**Amendment to Update the Deer Creek Mining and
Reclamation Plan, Volume 11, North Rilda Canyon Portal
Facilities, PacifiCorp, Deer Creek Mine, C/015/0018, Emery
County, Utah Task ID #3613**

Subj: Clean Copy Submittal for the Amendment to Update the Deer Creek Mining and Reclamation Permit, Volume 11, North Rilda Canyon Portal Facilities, PacifiCorp, Deer Creek Mine, C/015/0018, Emery County, Utah. Task I.D. #3613.

Detailed Schedule Of Changes to the Mining And Reclamation Plan

ENERGY WEST MINING COMPANY A SUBSIDIARY OF PACIFICORP	
TYPICAL PORTAL SEAL	
DRAWN BY: K. LARSEN	Figure R645-301-500d
SCALE: NONE	DRAWING #:
DATE: JUNE 22, 2010	SHEET <u>1</u> OF <u>1</u> REV.

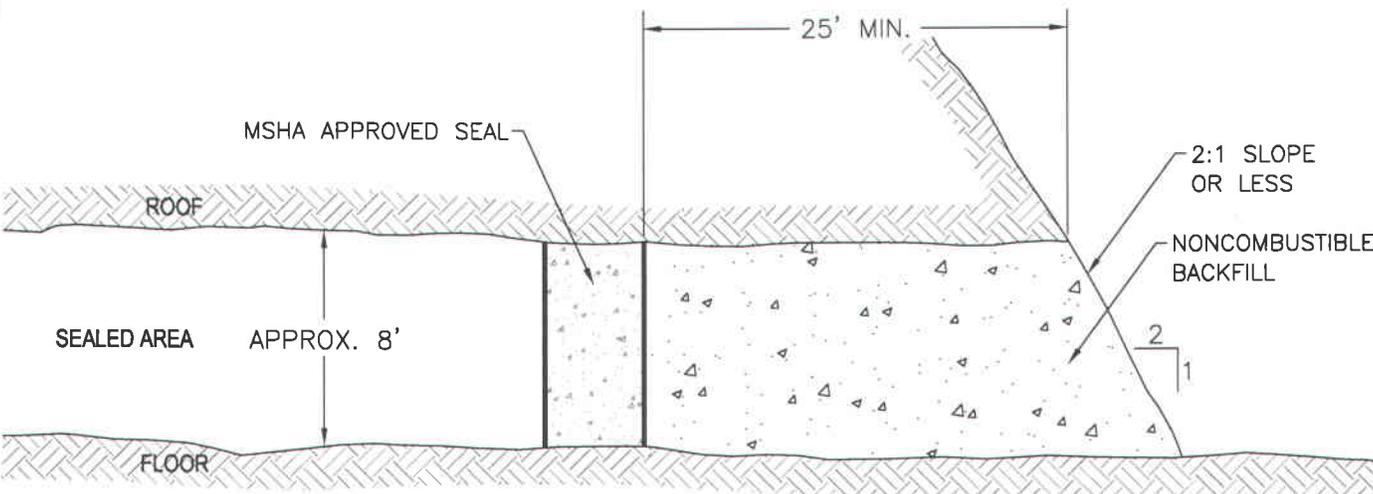
Figures Section – Replace R645-301-500d
